**Re: Revised Figure for Addendum No. 1 to
Removal Action Work Plan - Upper ½ Mile Reach of Housatonic River
General Electric Company, Pittsfield, Massachusetts**

GENERAL ELECTRIC COMPANY
PITTSFIELD, MASSACHUSETTS
REMOVAL ACTION WORK PLAN -
UPPER 1/2-MILE REACH OF HOUSATONIC RIVER

FIGURE
7-1D

Andrew T. Silfer, P.E.
Project Coordinator

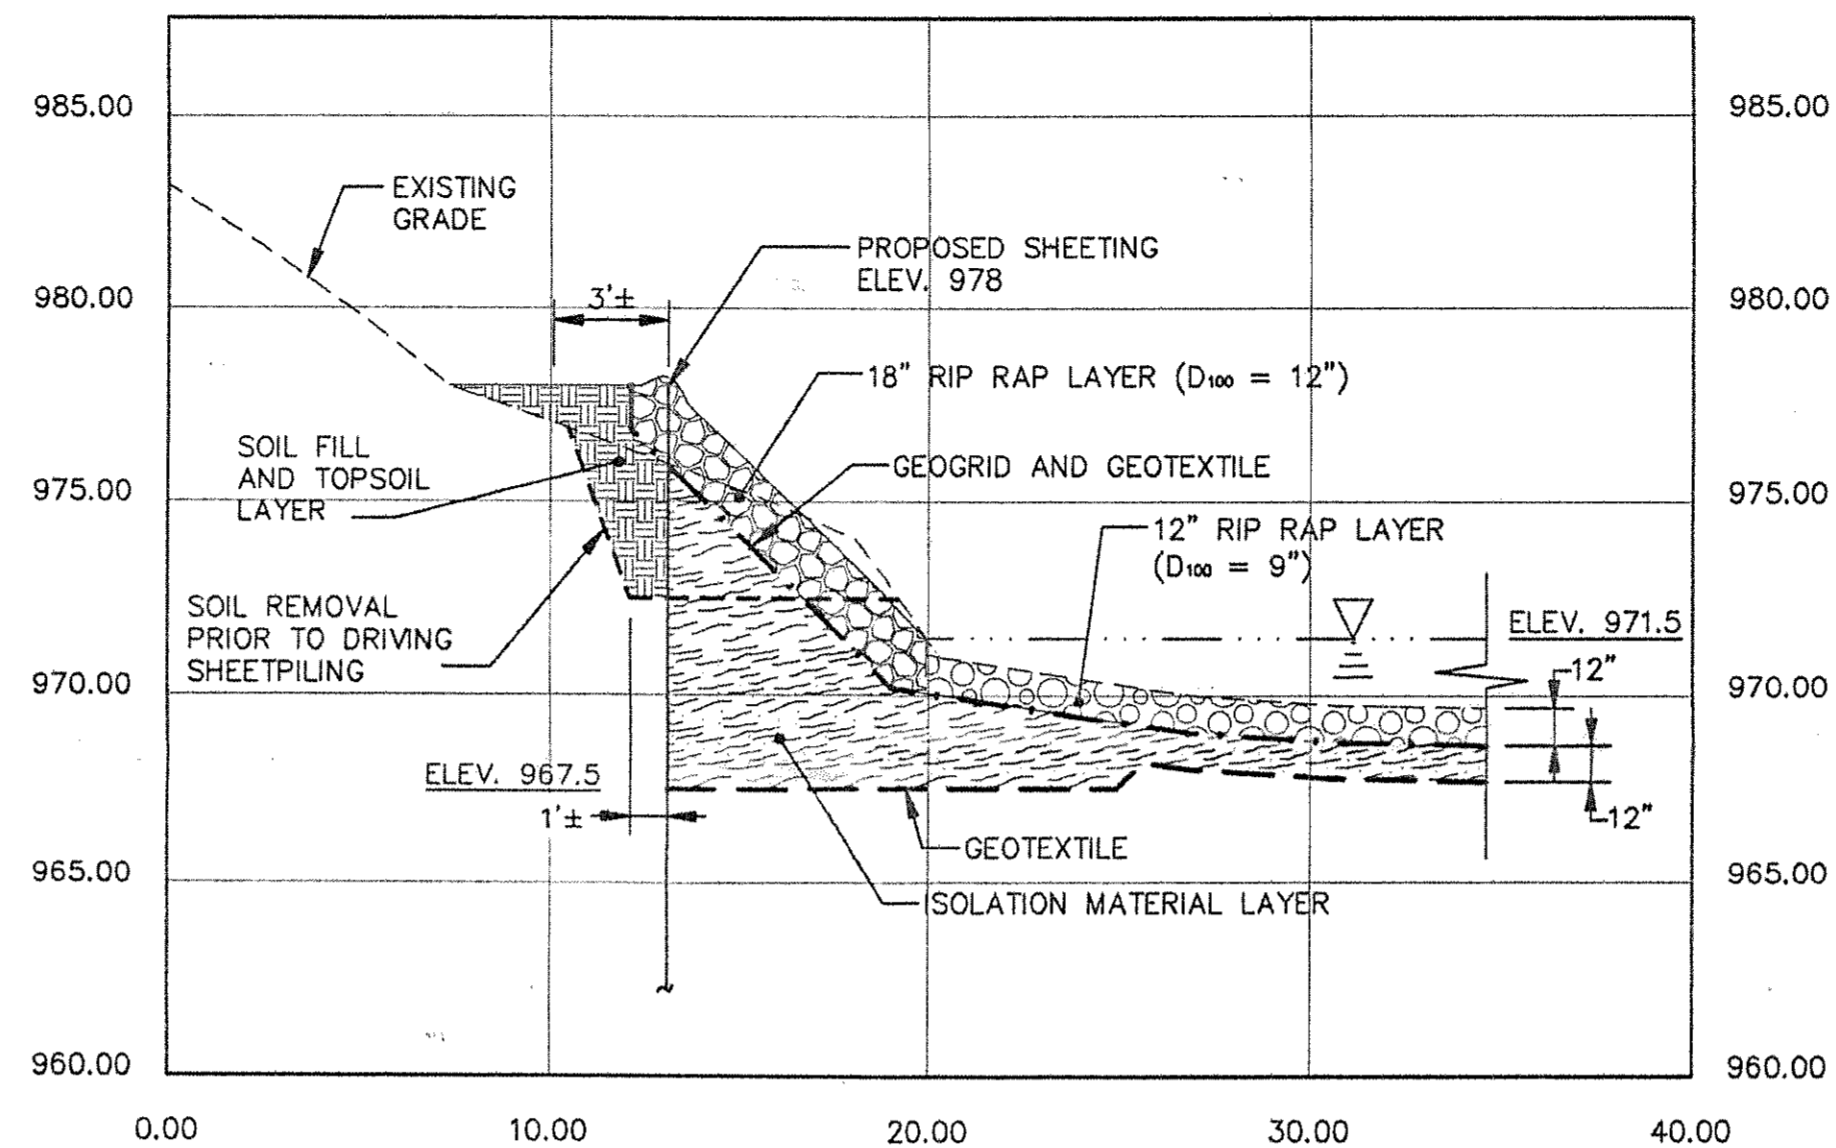
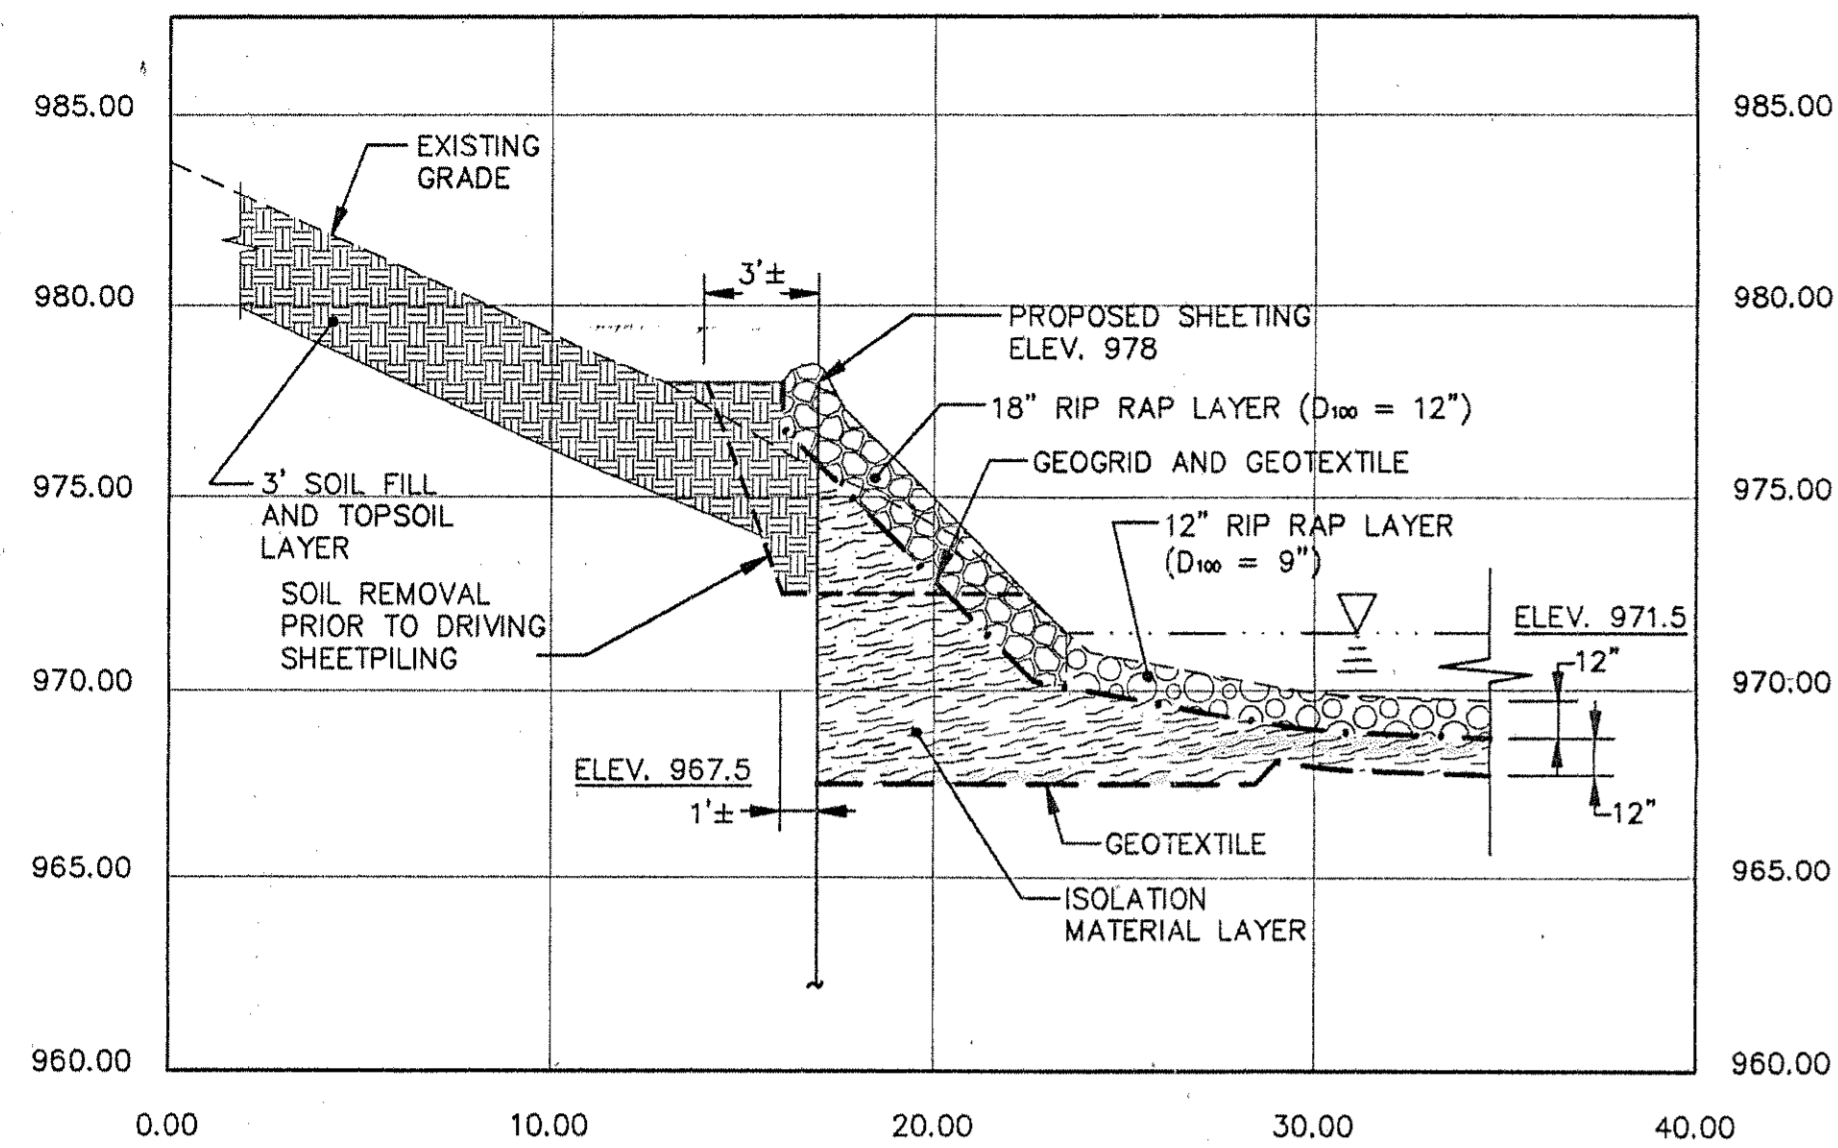
On November 4, 1999, the General Electric Company (GE) submitted an addendum (Addendum No. 1) to GE's *Removal Action Work Plan - Upper ½ Mile Reach of Housatonic River* [Blasland, Bouck & Lee, Inc. (BBL), August 1999]. That Addendum No. 1 presented information on two figures (Figure 4-4 and Figure 7-1D) associated with construction and restoration activities in the Upper ½-Mile Reach of Housatonic River adjacent to the Lyman Street Area (as defined in the Consent Decree). Subsequently, on December 3, 1999 EPA issued a letter to GE regarding Addendum No. 1 documenting GE's prior agreement with EPA to make certain modifications to Figure 7-1D of Addendum No. 1. In accordance with that letter, Figure 7-1D has been revised and is enclosed.

No.	Date	Revisions
1	11/4/99	ADDENDUM No. 1 -- SECTIONS V-V' THROUGH AA-AA'
2	1/7/00	REVISIONS PER EPA'S 12/3/99 LETTER

1. THE LOCATION OF THE SHEETPILE SHOWN IS APPROXIMATE AND WILL BE FIELD ADJUSTED BASED ON TOPOGRAPHIC CONDITIONS TO CREATE A MAXIMUM BANK SLOPE OF 1H:1V (I.E., NO STEEPER THAN A 1:1 SLOPE) FOR THE RESTORED BANK FROM THE RIVER'S EDGE TO THE TOP OF SHEETING.
